#### CLUTCH CHATTER 1600-1601

### LOOSE MOTOR SNUBBER LINKS 1700-1701-1703

#### GEAR SHIFTER LEVER RATTLE 1700-1-2-3-5

### CONNECTING ROD BEARINGS 1700-1701

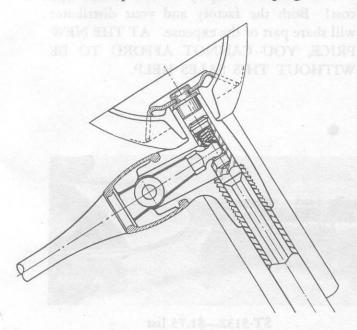
We have made a change in production to increase the clearance of the upper end of the gear shifter tube in the steering wheel hub cup and have added a plug and anti-rattle spring.

These new parts may be installed in the earlier cars where a rattle has developed due to excessive clearance at the upper end of the gear shifter tube.

Remove the steering wheel and press the antirattle plug into the upper end of the shifter tube. Engage the spring with the groove in the plug and snap the ends in against the reinforcing wall of the steering wheel hub cup to put a tension on the tube.

Even a slight misalignment or a close fit of the gear shifter tube in the steering wheel cup may make the shift objectionably stiff. When this condition is encountered the tube should be freed up and given about .003 inch clearance in the cup. The anti-rattle plug and spring should then be installed to prevent a rattle developing.

338043—Steering Column Anti-rattle Spring Plug 338044—Steering Column Anti-rattle Spring

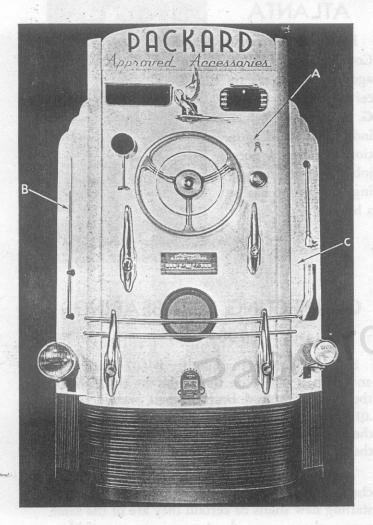
Starting with motor number B4607 on the Six and with B303053 on the Eight the thickness of the connecting rod bearing shell was increased .010 inch. This increased the outside diameter of the shell .020 inch and required that the bore of the connecting rod be increased.

The thin and thick bearing shells are not interchangeable in the connecting rods. When installing new shells be certain they are of the same type as those removed. A positive means of identification is by the number forged on the shank of the connecting rod.

Forging No. 330613—requires thick bearing assembly—standard Piece No. 338827.

Connecting rod bearing shells are interchangeable in the 120-120B-120C-115C-1600-1601 and 1700-1701 previous to the above motor numbers and are supplied in standard .001", .002" and .003" undersize. Bearing shells are marked with a rubber stamp to indicate their size. In addition to the size marking, the new thick shell bearings will be identified by a star stamped near the size marking.
